Village of Arlington Heights
Plan Commission
Board Room
Arlington Heights Village Hall
33 S. Arlington Heights Road
Arlington Heights, IL 60005
February 28, 2018
7:00 PM

RE: PARA RESIDENCE - 132 WEST NORTHWEST HIGHWAY - PC#17-015
PUD VARIATIONS

HEART'S PLACE
120-122 EAST BOEGER DRIVE
ARLINGTON HEIGHTS, ILLINOIS

C2.0

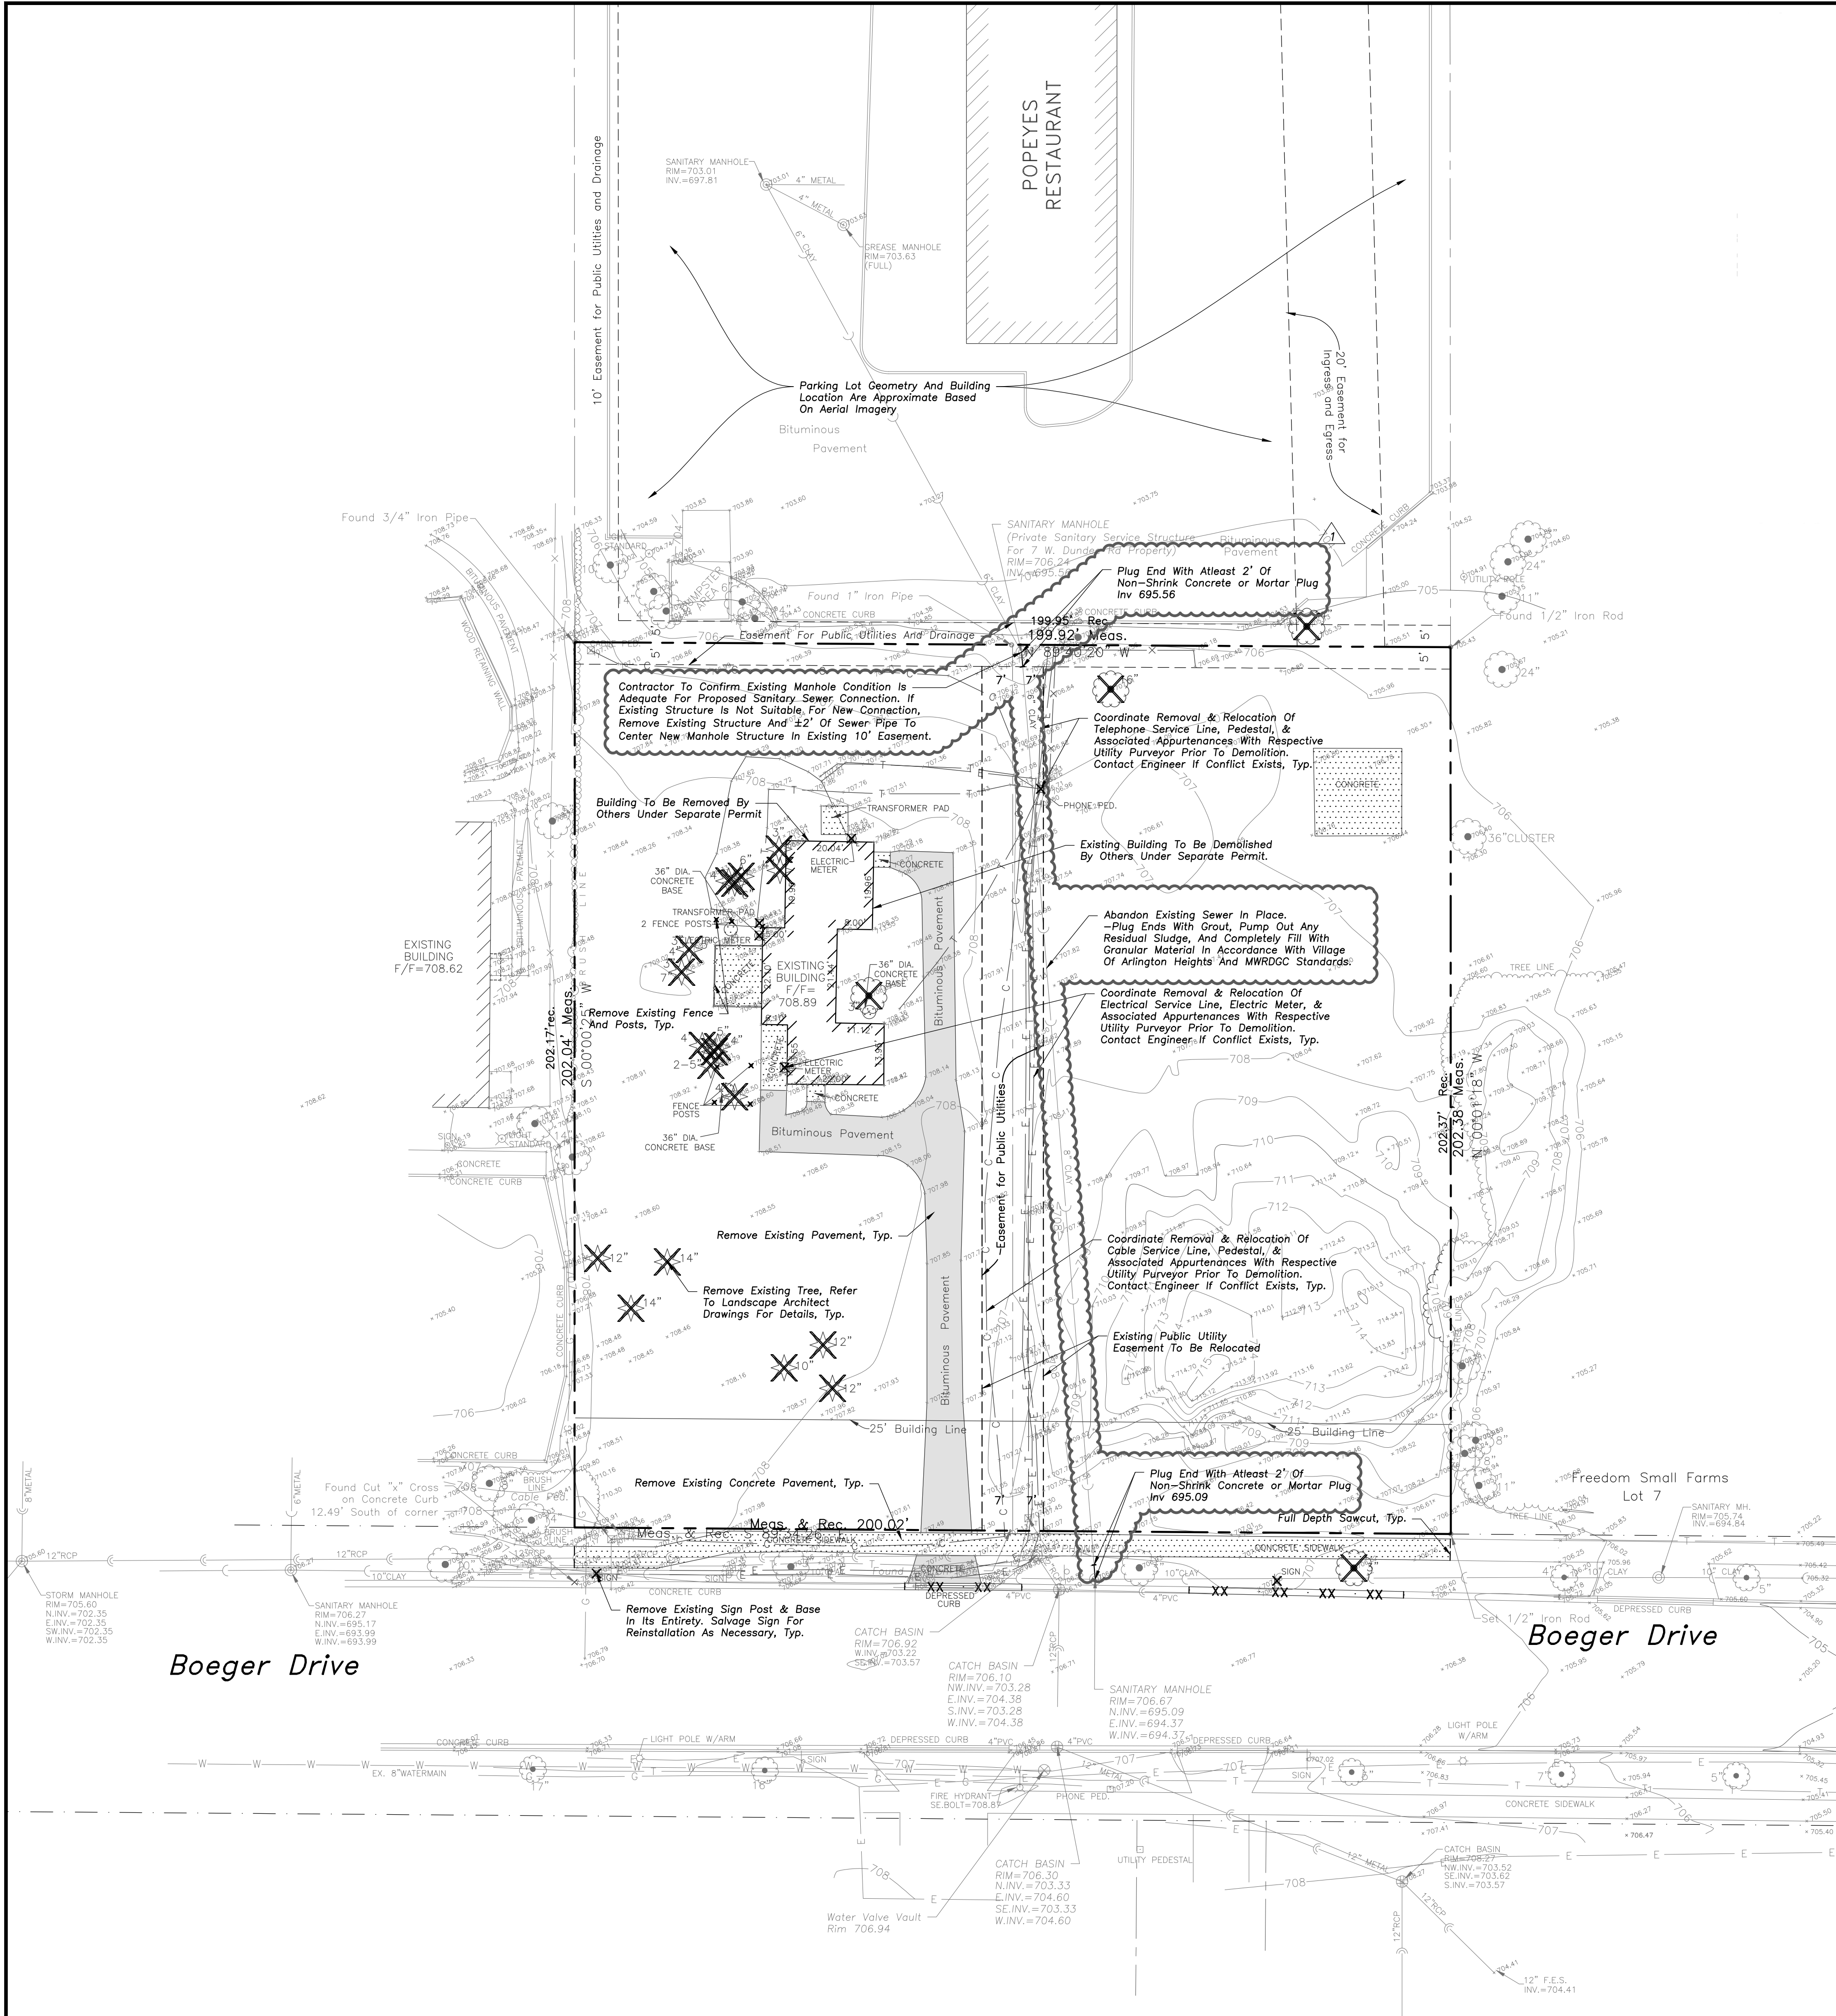
9. The alternate hatching for the public sidewalk vs. the private sidewalk is acceptable.
10. Sheet C-2.0: The public sidewalk shall take precedence over the curb through the driveway. Stop the curb on either side of the public sidewalk.

11. Sheet C-2.0: The east-facing parking stalls can be 16.5' in depth to the face of the curb, allowing for 1.5' of overhang over the curb. The west-facing parking stalls can also be 16.5' in depth to the face of curb as long as the adjoining sidewalk is also widened 1.5' to account for the overhang and not reduce the walking area. If the 18' stall depth dimension is kept, wheel stops should be installed to eliminate vehicle overhang.

12. Sheet C-2.0: The handicap sign for the northernmost handicap parking space should be positioned 8' to the south, in the middle of the proposed handicap space.
